**Agenda Item D.2  
PRELIMINARY REVIEW  
Meeting Date: May 26, 2026**

**TO:** Goleta Design Review Board

**FROM:** Brian Hiefield, Senior Planner

**SUBJECT:** New Anthem Church Facility and Improvements to Christ Lutheran Church 6595 Covington Way (APN 077-160-022) Case Nos. Case No's 24-0004-CUP(AM), 24-0010-DP(AM); 24-0030-DRB; 24-0009-DP, 24-0002-SUB, & 24-0005-CUP

CONCEPT ELEVATION NORTH  
1/8" = 1'-0" 02

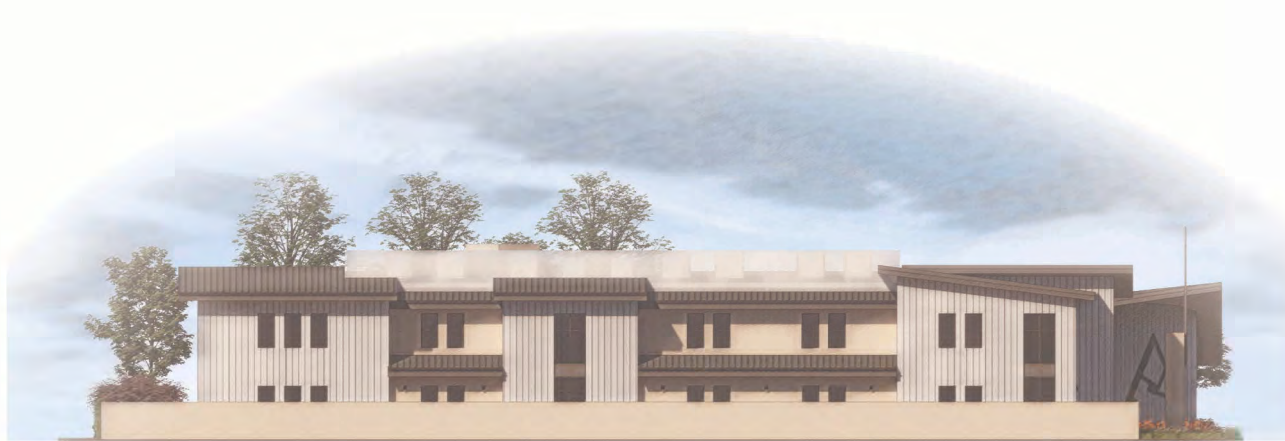
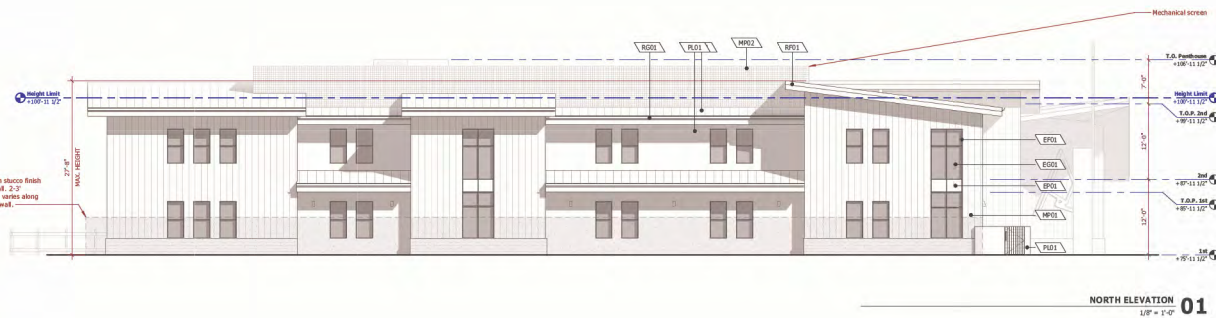
### *DRB Comment: Concerns with Building Mass*

*Applicant's response:* In response to this comment, the north facade has been broken into a handful of planes, and the roofs are set at varying plate heights to turn the flat facade into a highly articulated elevation. On the first level, walls have been moved in and even further on the second level. This creates a staircase effect to break down the mass both visually and literally as square footage has been reduced. Building material change at the stepping of the facade further reduces the overall perception of a single large wall, with rhythmic, smaller windows intended to fit in with the residential character of the neighborhood.
